STAFF REPORT: 01-22-2020 MEETING

APPLICATION NUMBER: 20-6648

ADDRESS: 8116 - 8130 KERCHEVAL/THE KERCHEVAL 3

HISTORIC DISTRICT: WEST VILLAGE

LEFT SIDE (EAST) ELEVATION -8130

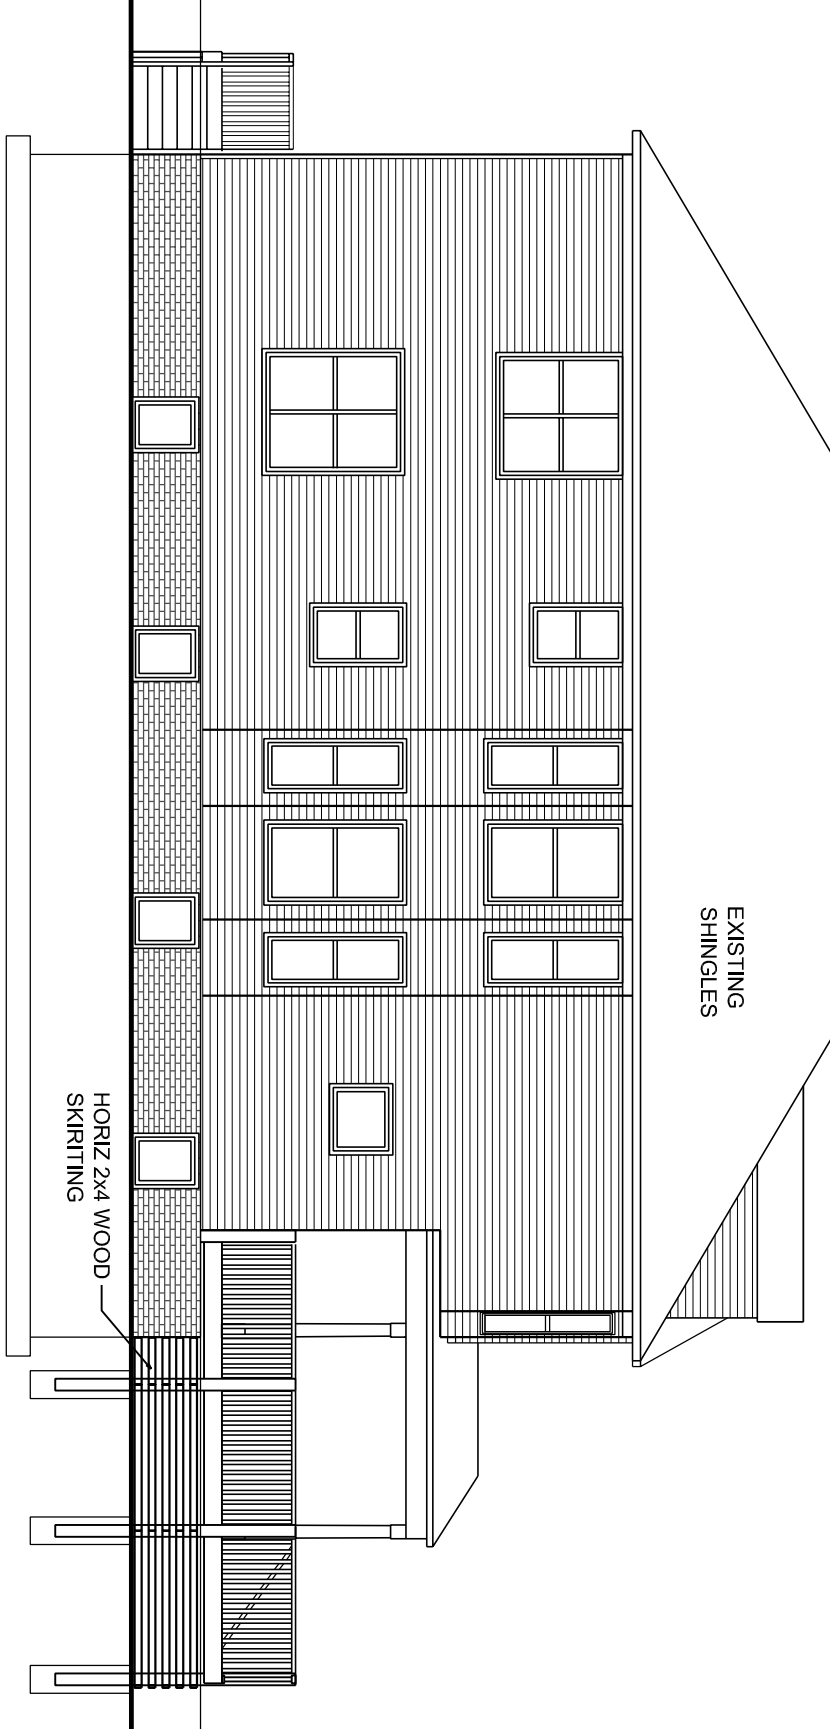
- 8122: A door was removed on the east elevation, and a door opening, closer to the rear, was added.
 - 8126-8130: Two windows were removed on the west elevation, near the middle of the structure. Two windows were shortened on the east elevation, toward the rear.

Windows reduced in size.
